**THE SAENGER
THEATRE RENEWAL
PROJECT**

DATE:	No.:	REVISION:
11.11.10		CONTRACT SET

SHEET TITLE:
THEATRE - MIDDLE
BALCONY LEVEL PLAN

M-1.07

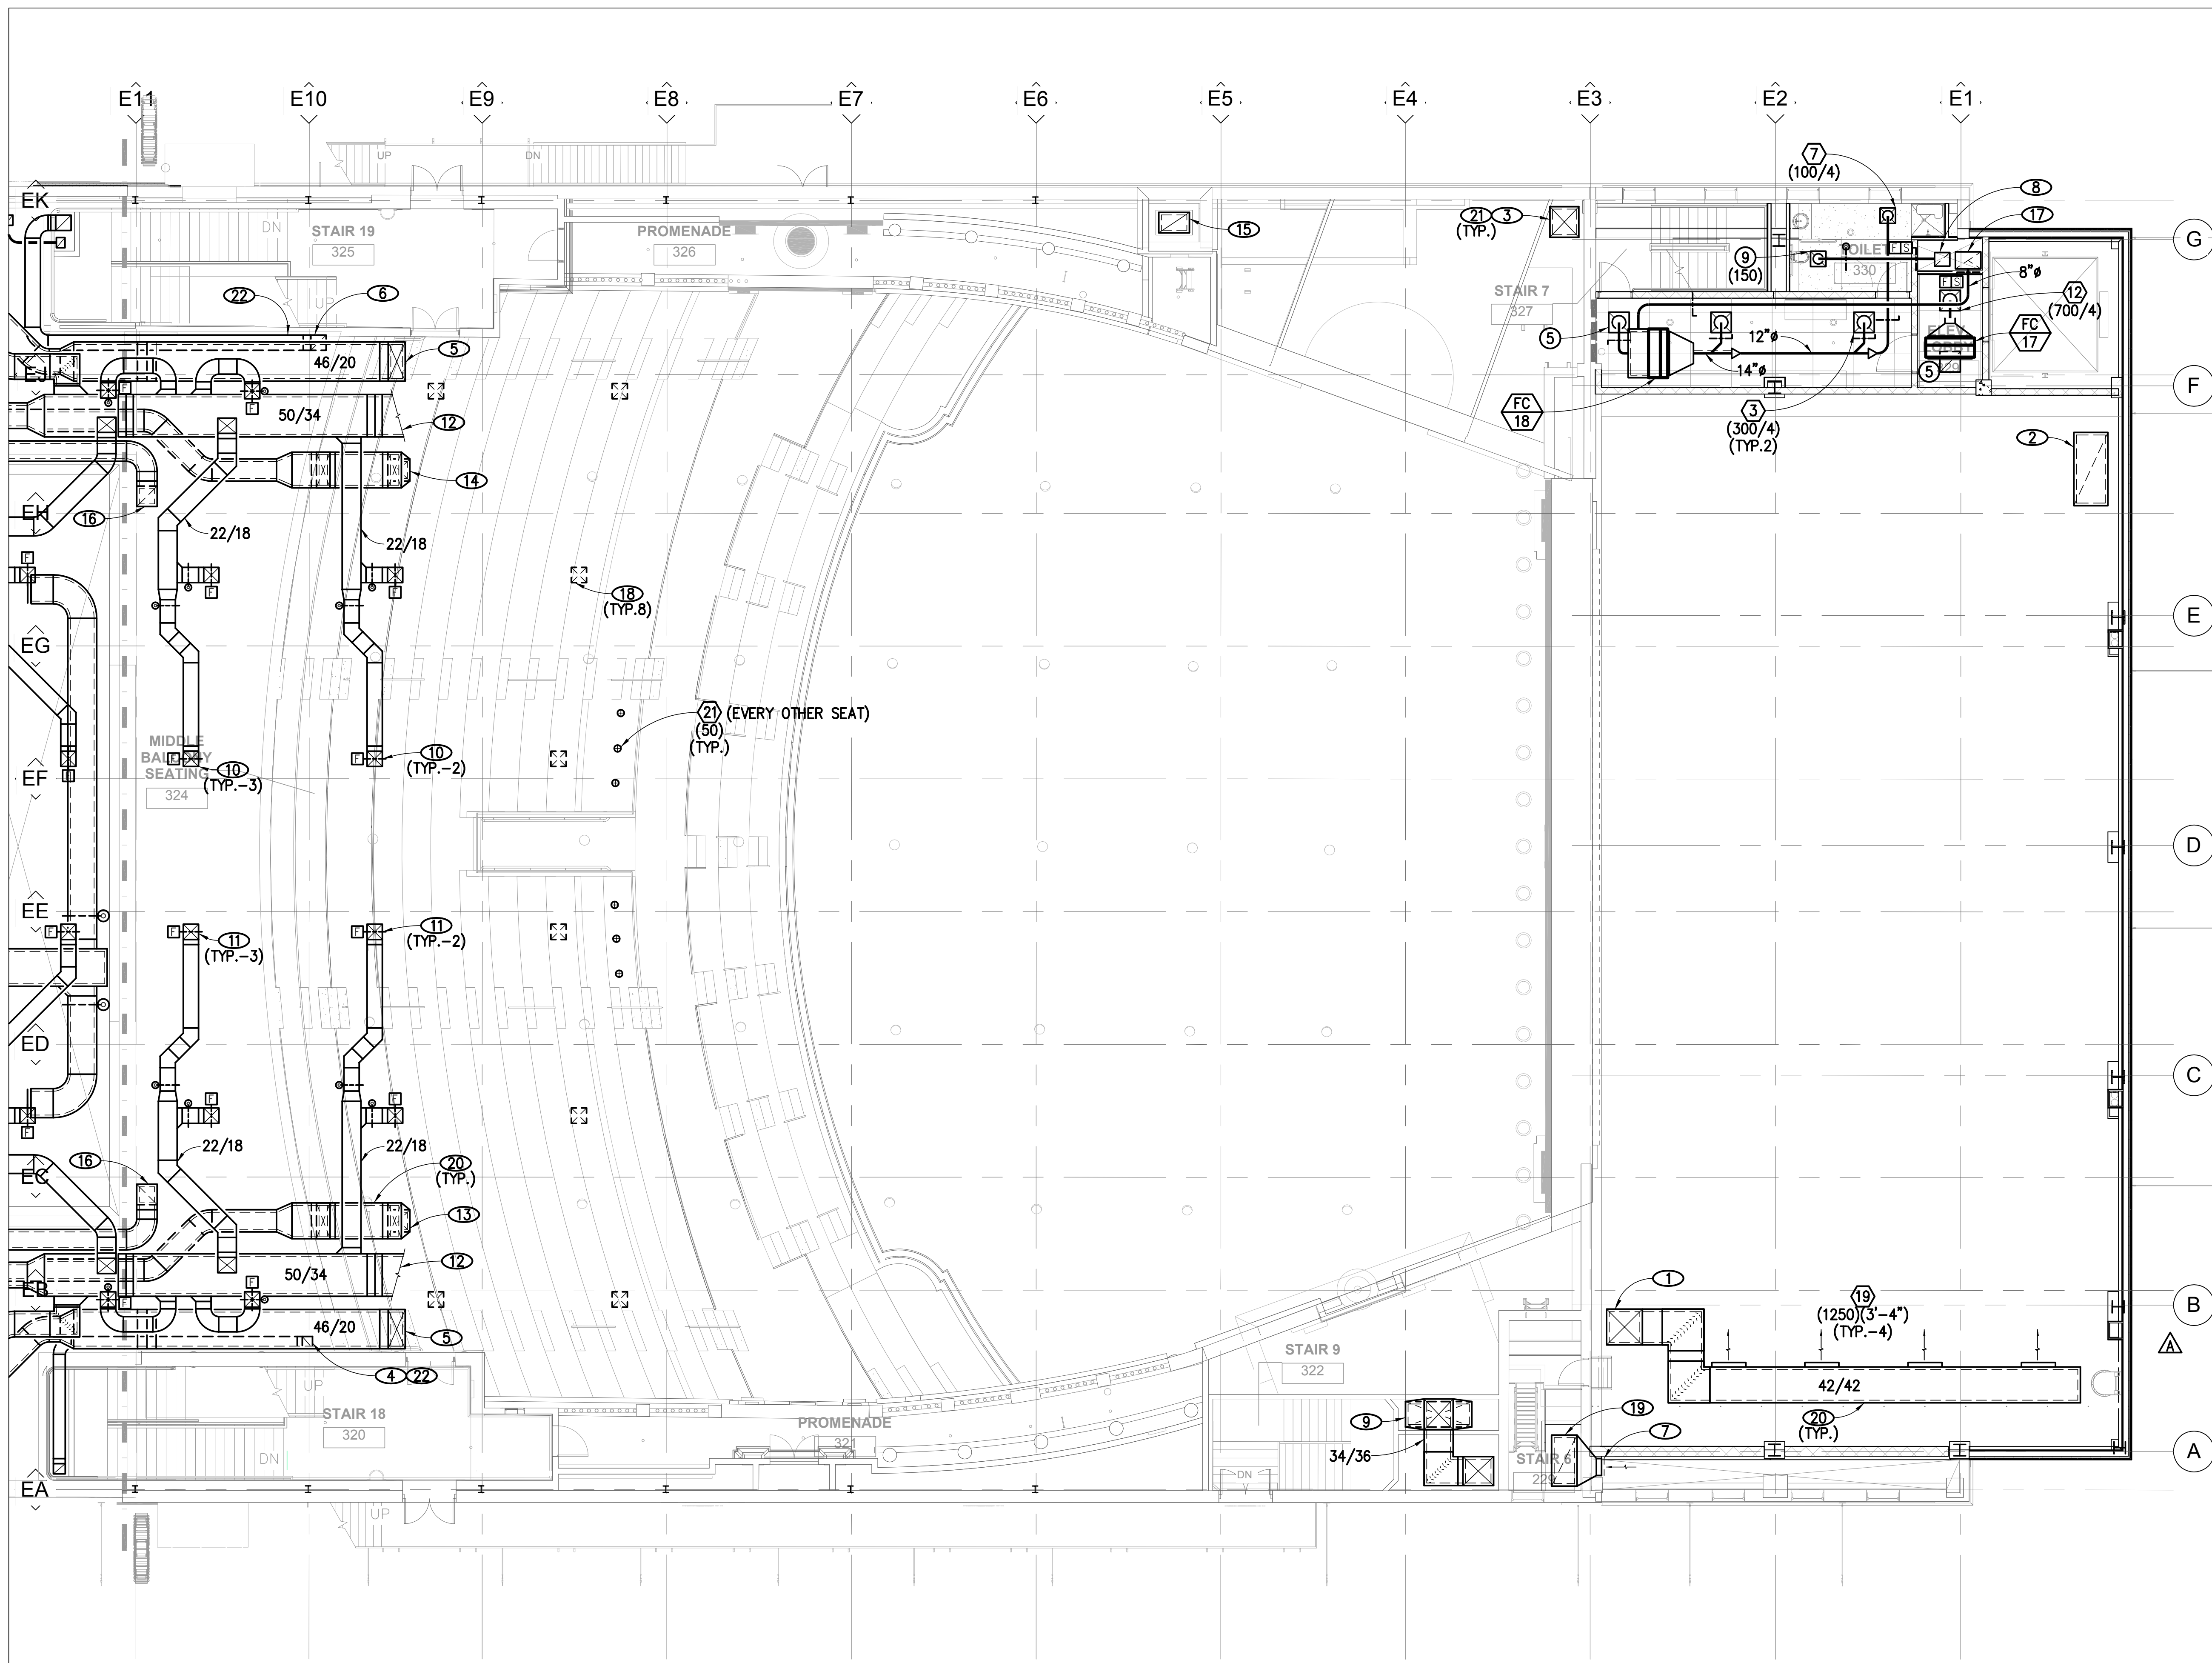
REVISED ENTIRE SHEET.
